APPLICATION NO.	FILING DATE	FIRST NAMED INVENTOR	ATTORNEY DOCKET NO.	CONFIRMATION NO.	
10/632,545	08/01/2003	Michael F. Brletich	12539	2681	
7590 08/01/2007 PAUL F. DONOVAN			EXAMINER		
ILLINOIS TO	ILLINOIS TOOL WORKS INC.			. GARCIA, ERNESTO	
3600 WEST LAKE AVENUE GLENVIEW, IL 60025			ART UNIT	PAPER NUMBER	
		·	3679	•	
		•	MAIL DATE	DELIVERY MODE	
			· 08/01/2007	PAPER

## **DETAILED ACTION**

FIG. 35

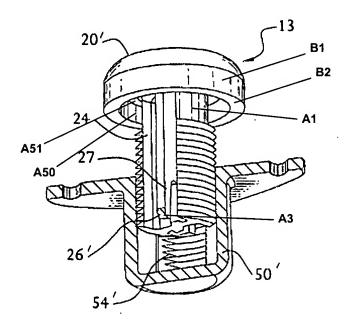
Regarding claim 1, Antonucci et al. disclose, in Fig. 35, a device comprising a fastener plug 13 including a plug portion 20' and a fastener portion 24. The plug portion 20' defines an end cap 20' and at least one disc 28 spaced apart from the end cap 20'. The fastener portion 24 defines a flexible extension member 27 extending outwardly from the end cap 20' and across the at least one disc 28. The extension member 27

includes a projecting member 26'. The end cap 20' includes at least one retaining wall A50 (see marked-up attachment) extending outwardly from an inner surface A51 of the end cap 20'.

Regarding claim 2, the end cap 20' defines a peripheral edge B1 (see marked-up attachment) and a flat surface edge B2 along the peripheral edge B1. Note, the claims are written with a broad breadth that Antonucci et al. reads on this claim. Applicants should consider rephrasing that the peripheral edge has a truncated edge or truncated surface.

Regarding claim 3, a rib A1 connects the disc 28 to the end cap 20'.

Regarding claim 7, the discs 28 define a flat surface edge A2.

Regarding claim 8, the projection member 26' defines an inclined surface A3.

examiner has pointed out in the rejection how Antonucci et al. shows a retaining wall extending outwardly from an inner surface of the end cap. Further, it should be noted that there is no positive requirement that the retaining wall seats against and within the open end of the bar since the bar is not claimed in combination with the device. Note that the device is for securing the bar and thus the device is claimed by itself.
